**EARA and SRA statement of case
APP/M1900/W/21/3278097**

Statement of Case

Application for the establishment of a new quarry on land at the former Hatfield Aerodrome, including a new access onto the A1057, aggregate processing plant, concrete batching plant and other ancillary facilities, together with the importation of inert fill materials for the restoration of the minerals working

Prepared on behalf of Ellenbrook Area Residents Association and Smallford Residents Association

Map of Ellenbrook Fields and the bromate plume

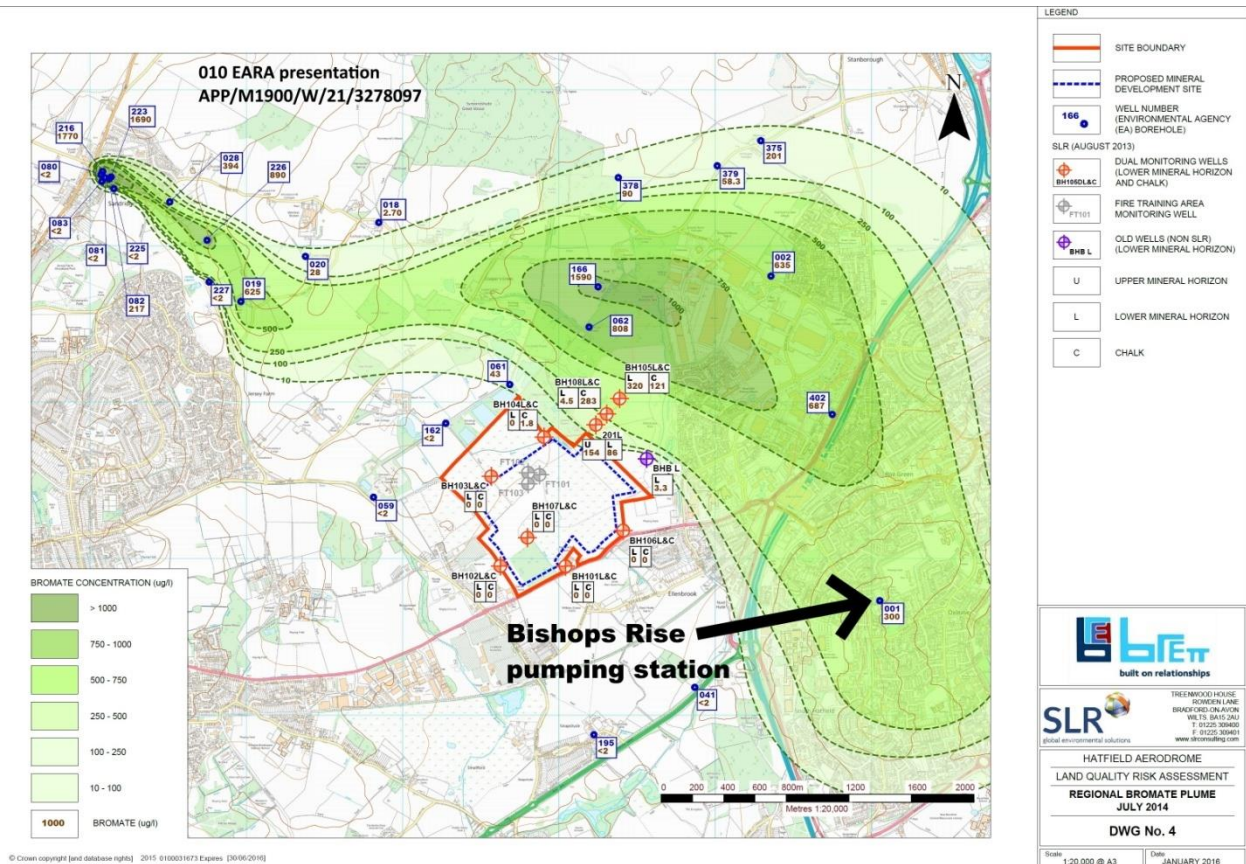
Clearly the magnitude of the bromate contamination was not taken into account when the Local Minerals Plan was drawn up.

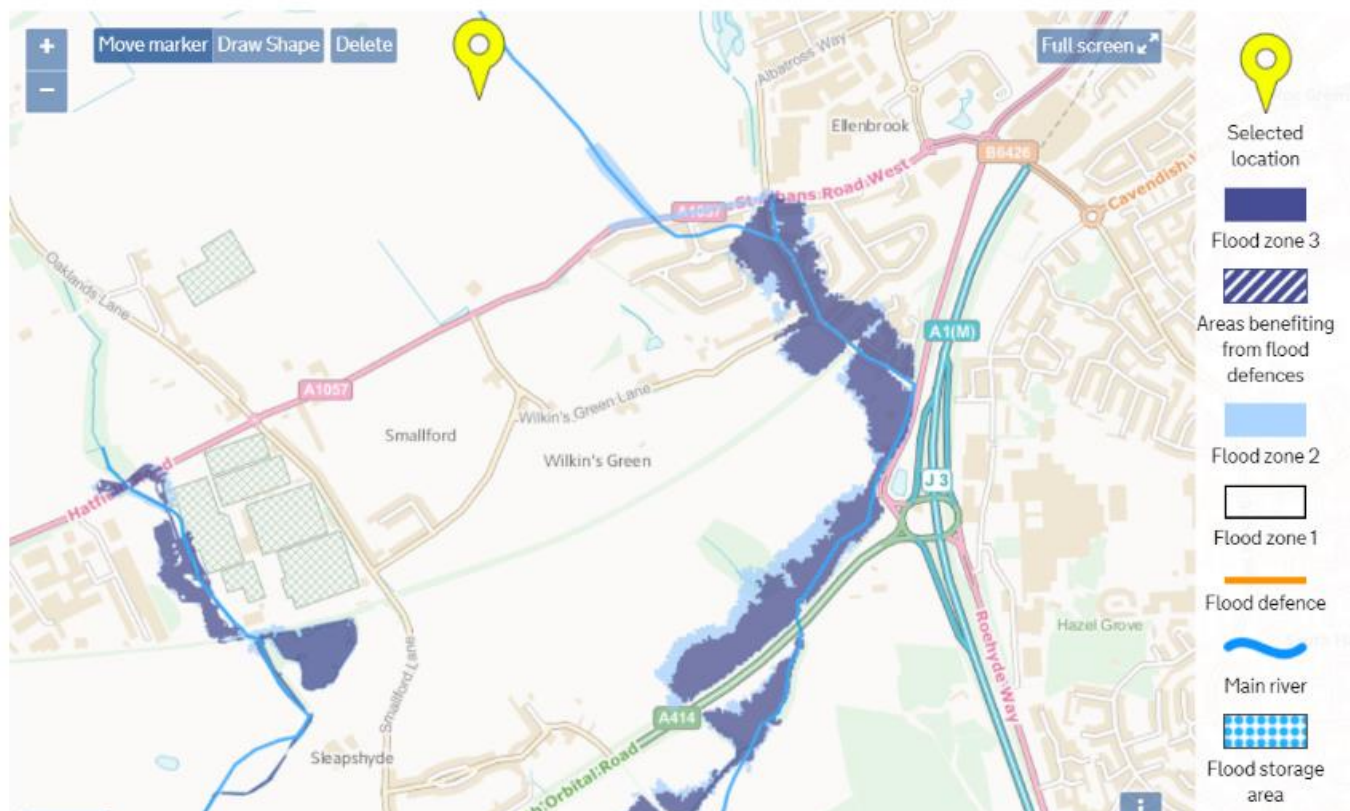
4.2.2 The quarry location slopes from 80 AOD (80' above sea level) in the N.W to 73 AOD in the S.E. As a result, natural surface water runs into the NAST, an ephemeral brook crossing the site where it eventually joins the Ellenbrook River, just south of the A1057 road. In laymans terms the

residential areas of Ellenbrook and Smallford are lower than the quarry site and water runs downhill!

Environment Agency position

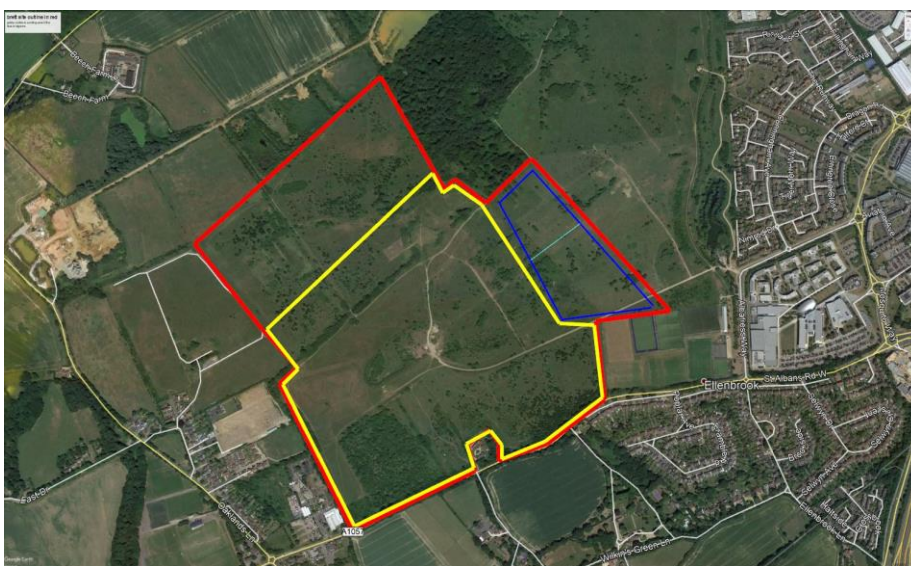
In the absence of an acceptable Flood Risk Assessment (FRA) we object to the grant of planning permission and recommend refusal on this basis for the following reasons:

The FRA submitted with this application does not comply with the requirements set out in paragraph 9 the Technical Guide to the National Planning Policy Framework. The submitted FRA does not therefore, provide a suitable basis for assessment to be made of the flood risks arising from the proposed development. In particular, the submitted FRA fails to:

1. Ensure that any off-site flood risk from the development site does not increase the risk of flooding to downstream properties in extreme flood events.
2. Demonstrate that the diversion proposals for the River Nast will not increase the risk of flooding on the development site in extreme flood events.
3. Consider the temporary diversion of the River Nast in an open channel.
4. Consider an open channel watercourse on the proposed permanent line of the River Nast after restoration.

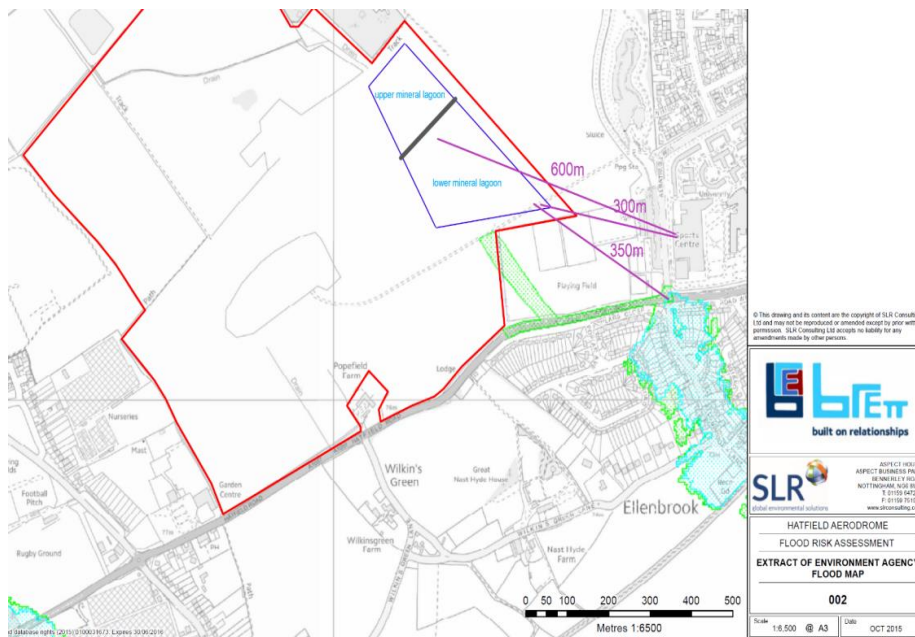
- 4.2.8 Issue 2 - Flood risk to the surrounding area if the proposed lagoons from the quarry overflow.
- 4.2.8.1 For the quarry to operate, as the sand is dug out, there is a need to get rid of excess water. The proposal put forward by the applicant is that this excess water will be stored in specially constructed lagoons and the water will infiltrate back into the ground over time.
- 4.2.8.2 The quarry site is huge, covering 86 hectares in total (shown in red) with a working area of 53 hectares (shown in yellow) which excludes the lagoons (blue) and plant site, as shown on the map below:

- 4.2.8.3 The quarry site is located in close proximity to the University of Hertfordshire, a busy main road and housing. The map below shows a natural slope to the S.E and a short distance of 300 metres to the university. It also shows how vulnerable we would be to the lagoons and subsequent flooding from them.

4.2.9.5 The map below shows the close proximity of the plume(green) to the site.

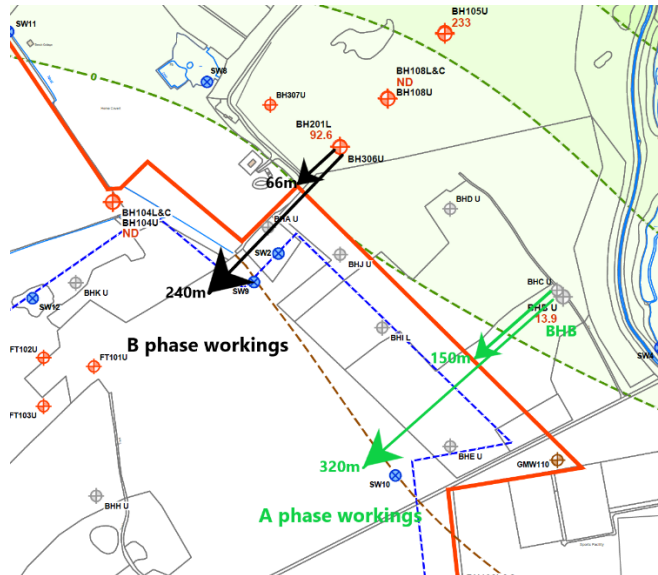
4.2.9.4 The bromate plume is too close to the site. Approximately 66 metres from the edge of the lagoon is borehole BH201 which shows high levels of

bromate 92.6µg/l. This borehole is situated N/E of the lagoon and directly below the UMA flow direction

**Environment Agency Maps – High Risk areas shown in Dark Blue –
Medium in Light Blue**

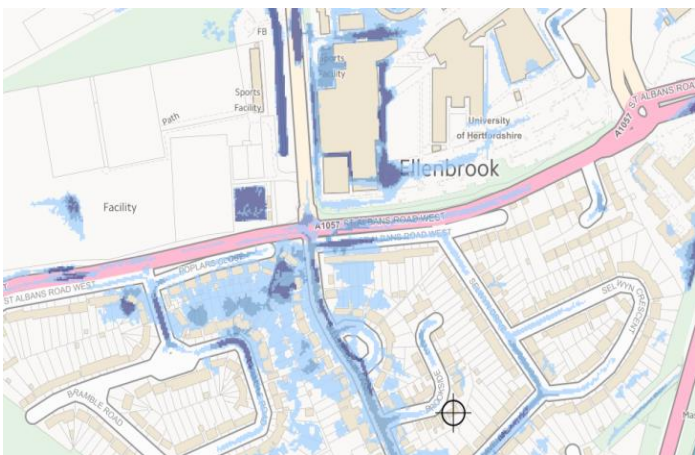
4.2.10.4 The area around the quarry is already at risk from river and surface water flooding as demonstrated on the EA maps below.
